ADDENDUM #04

Greene County Visitor Center Project
705 Main Street, County Road 23B, Leeds, N.Y. 12451
Kaaterskill Associates Project No.: 84517.06

Addendum 04 Issue Date: May 29, 2024

E-6

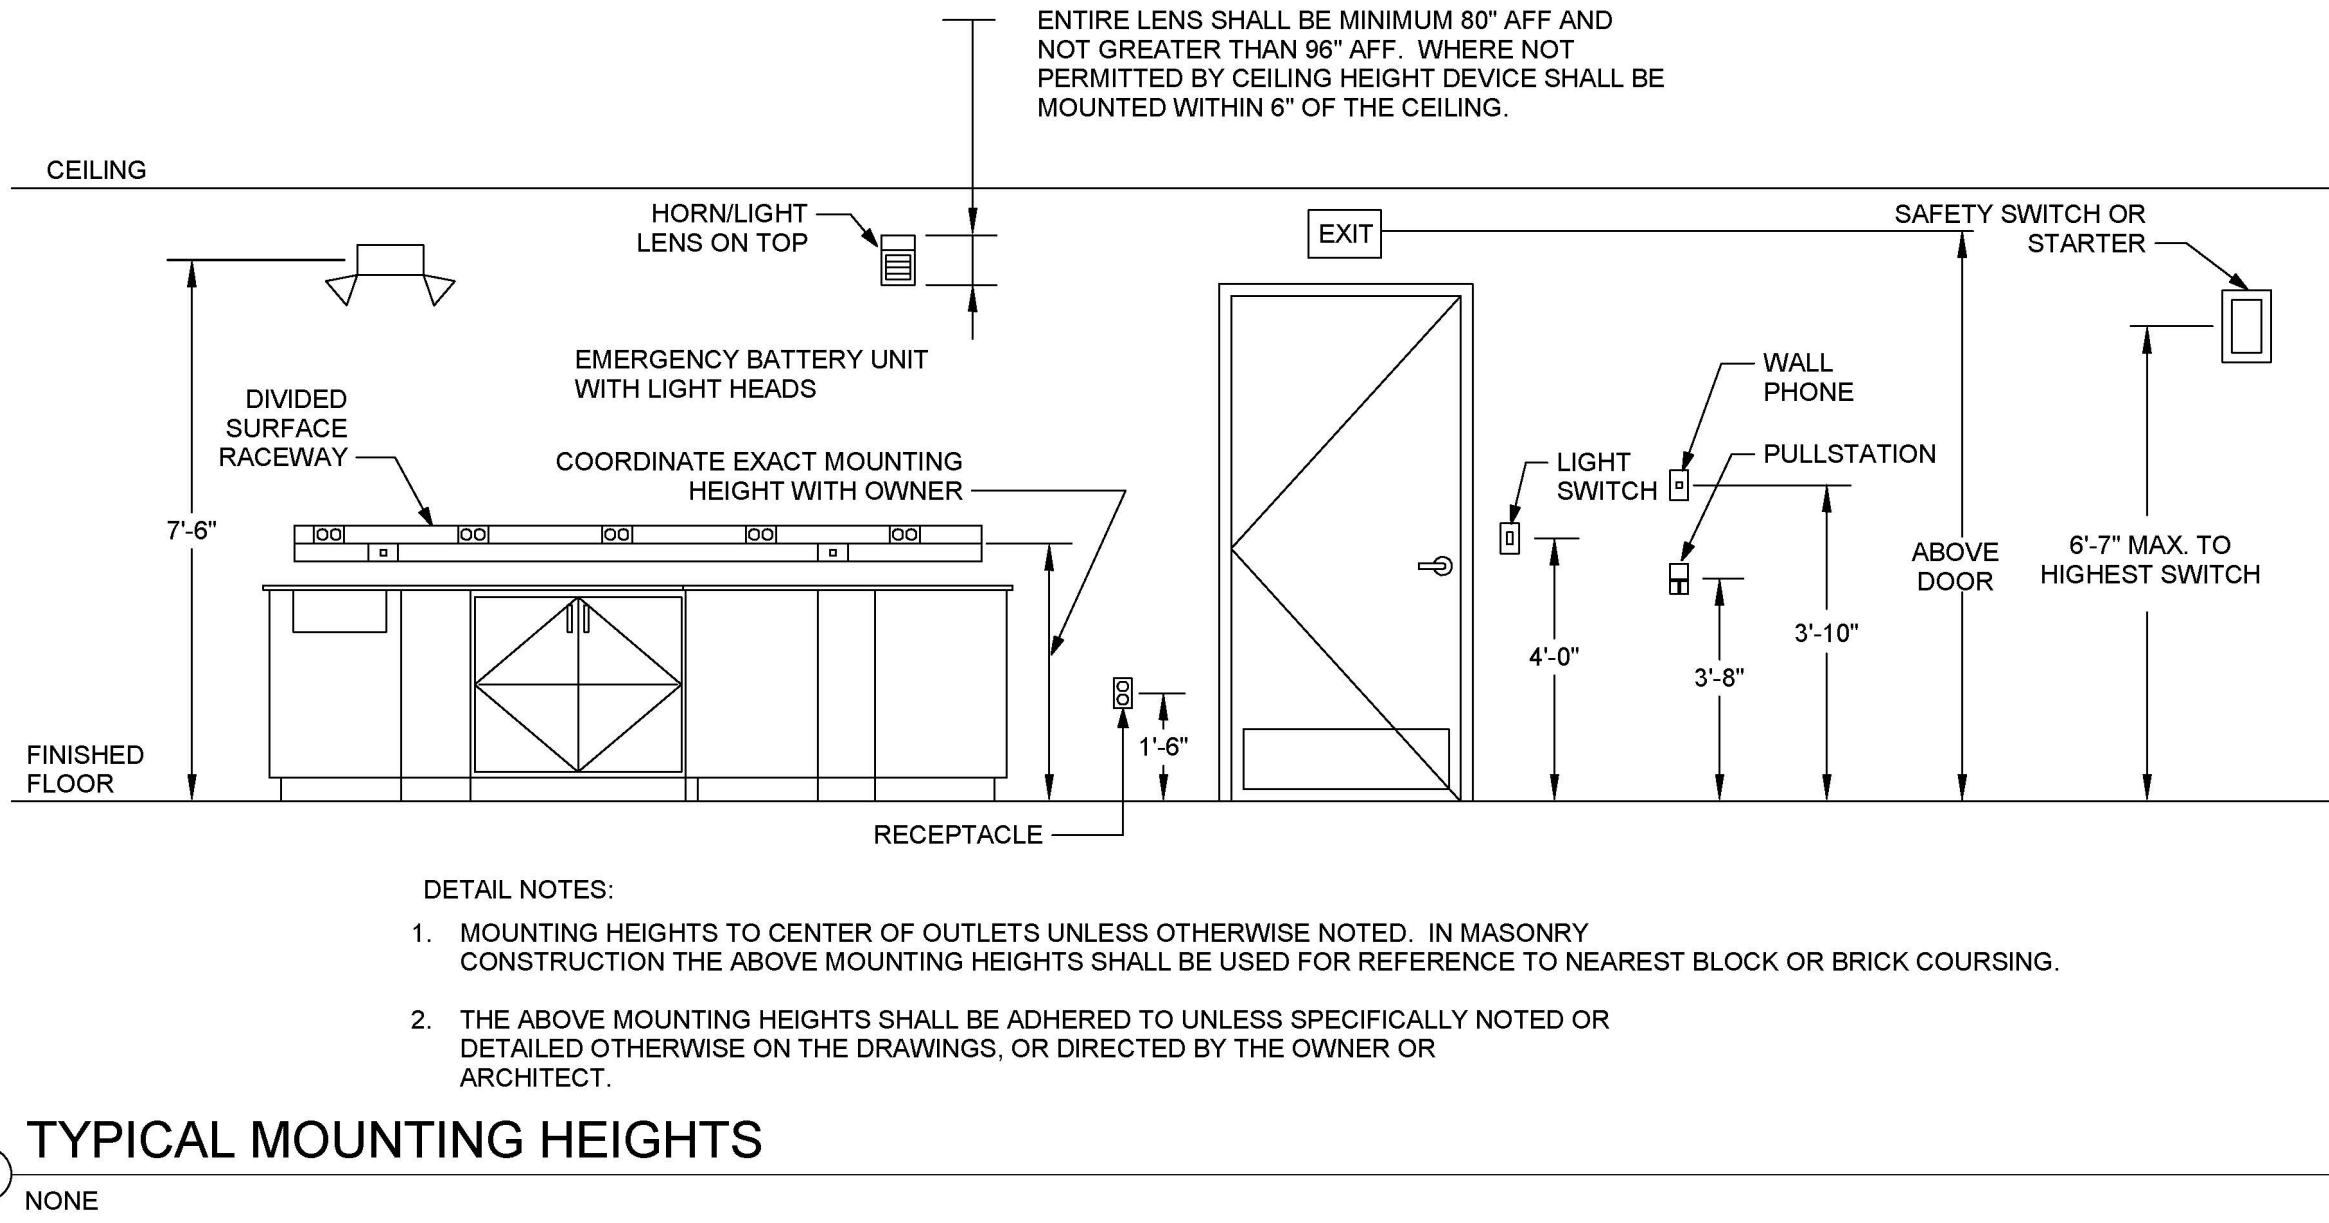
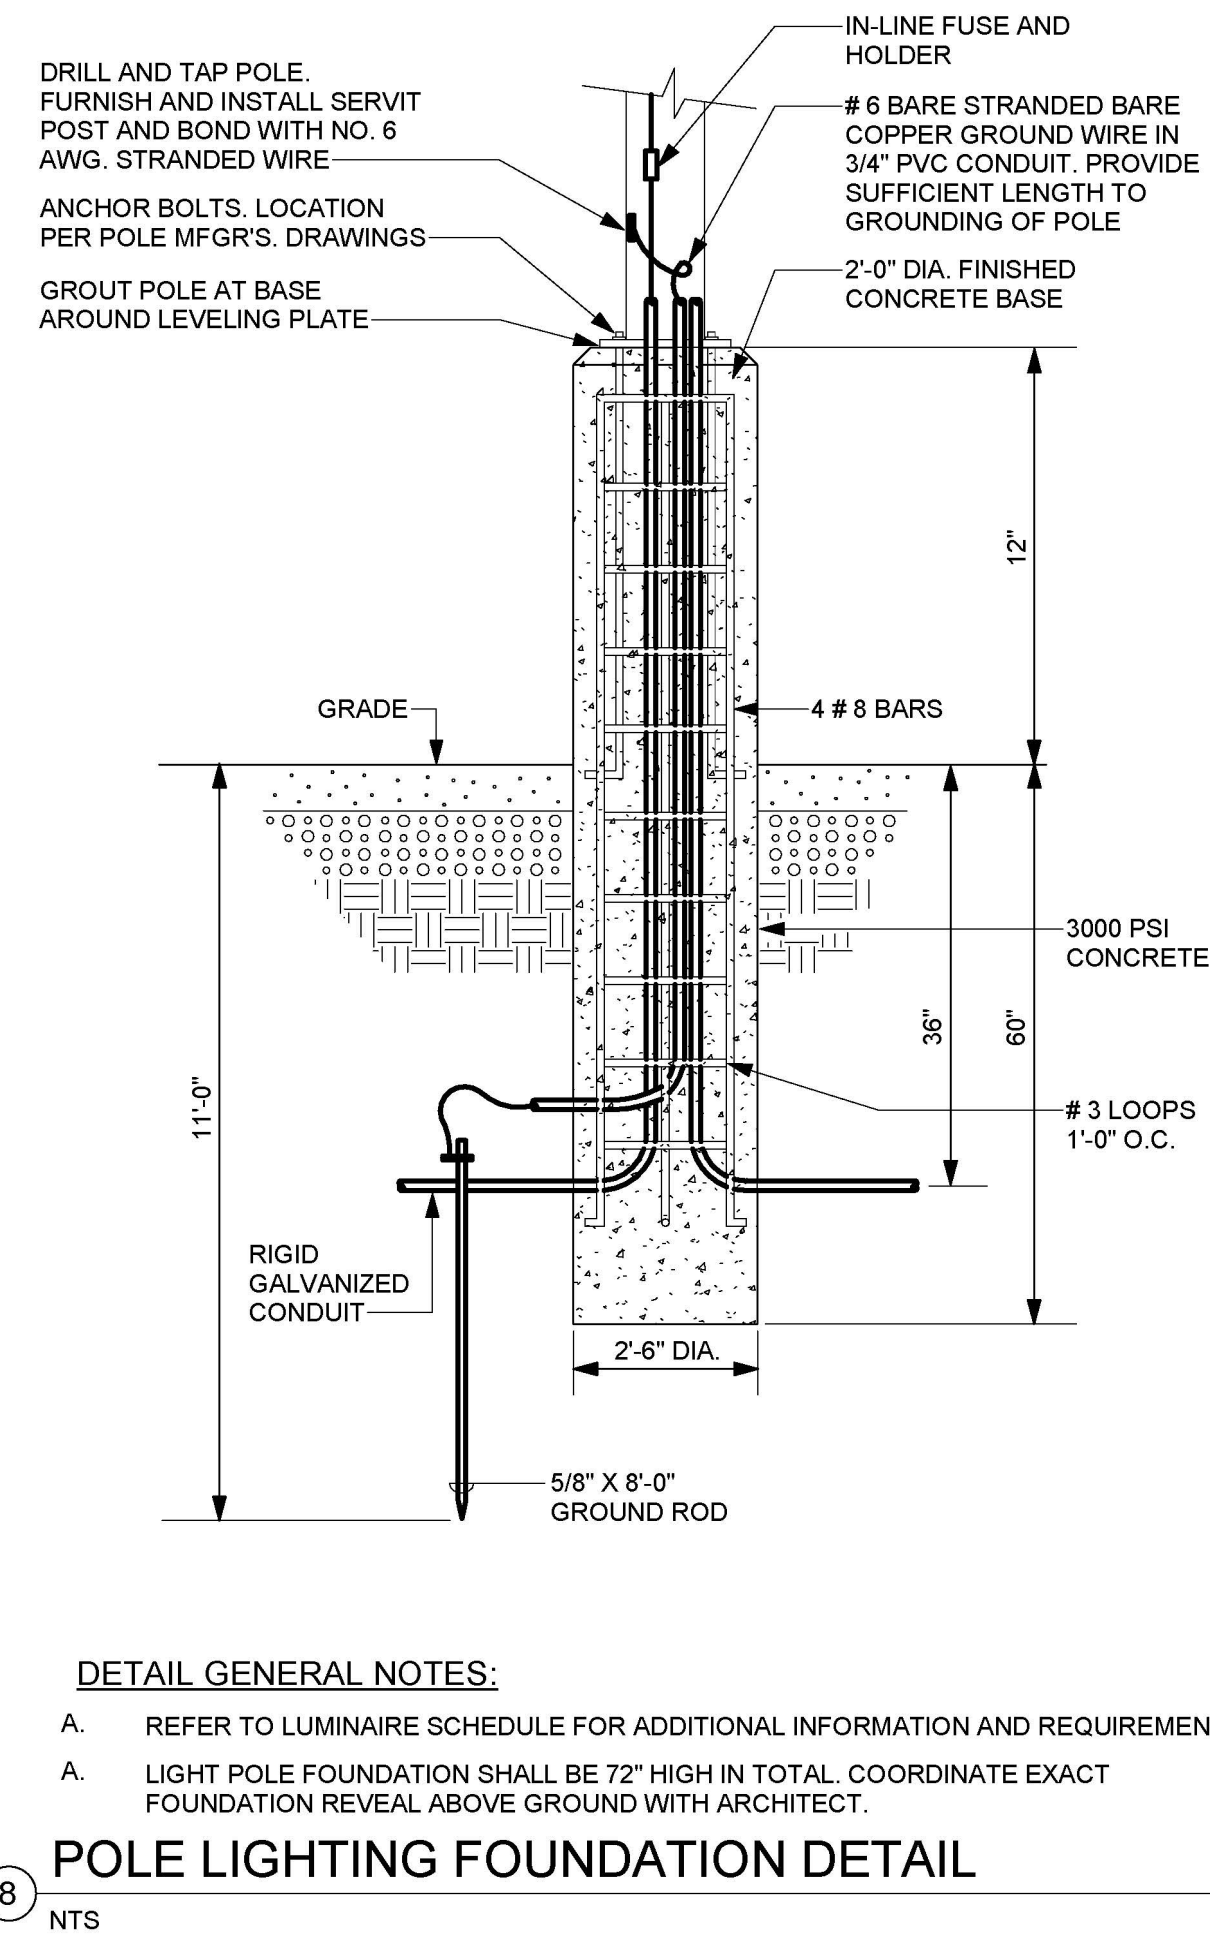
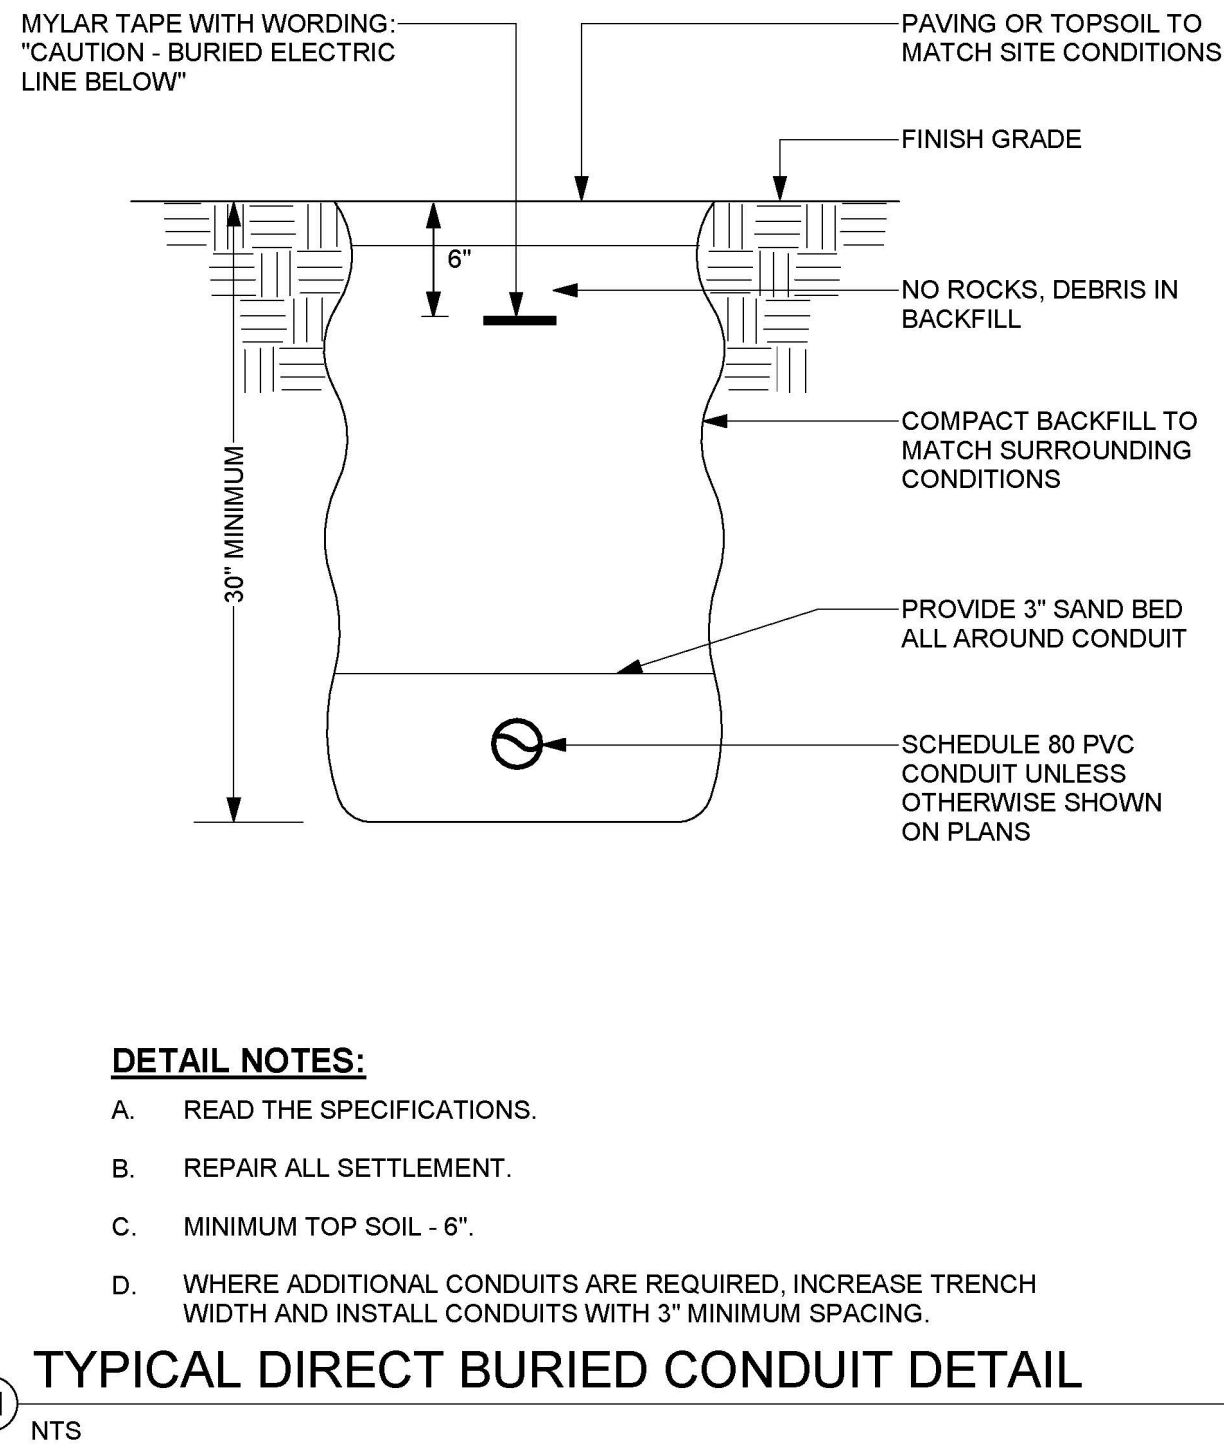
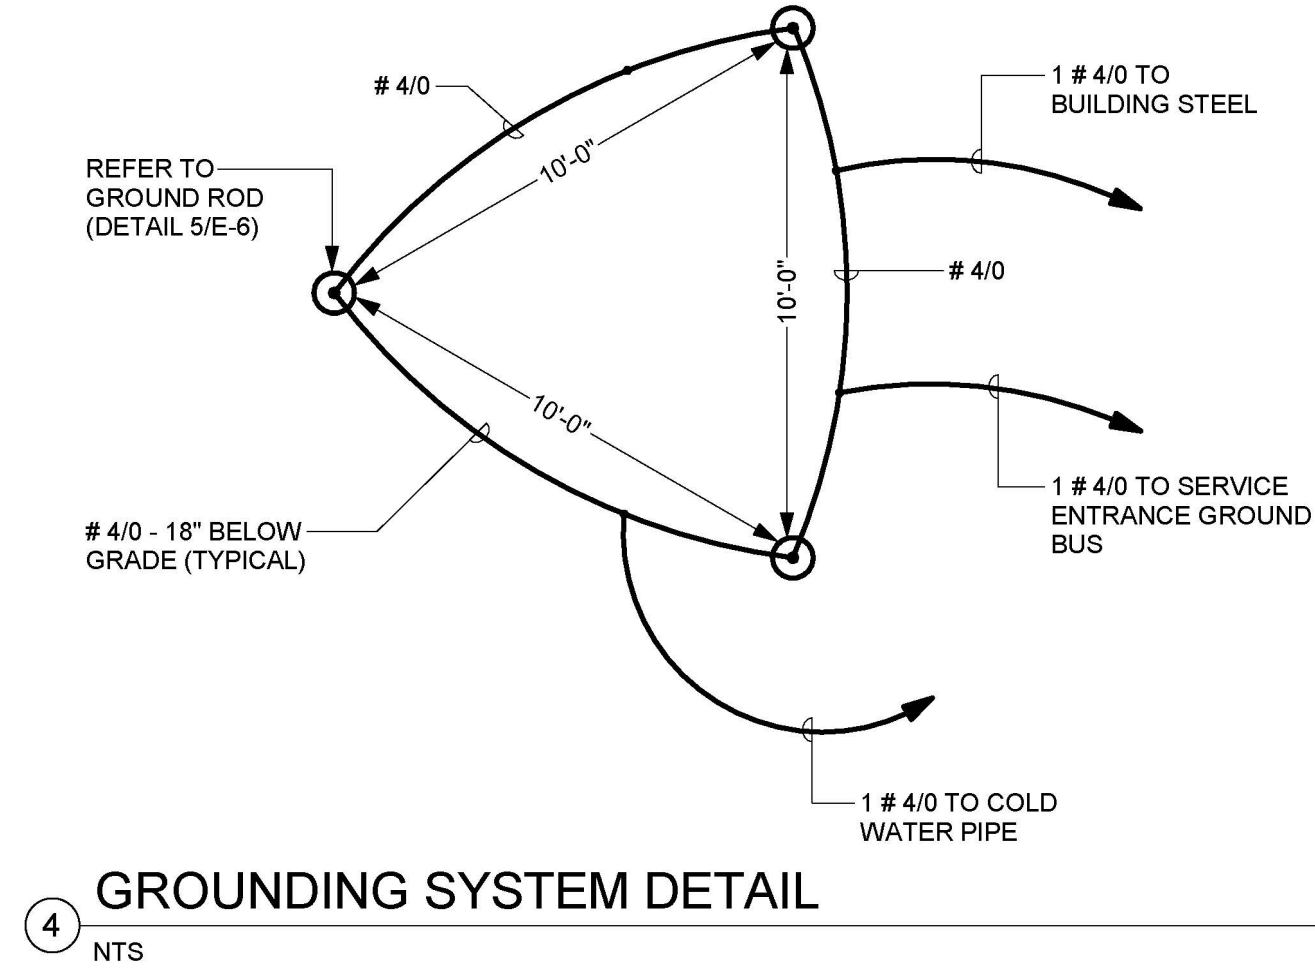
<u>Sheet/Detail</u>	<u>Description</u>
E-3	Added to current Bid Set: (see revision clouds)
E-6	Added to current Bid Set: (see revision clouds)
E-7	Added to current Bid Set: (see revision clouds)

A031: Refer to revised Electrical drawings E-1 through E-7, revision date 05/28/24.
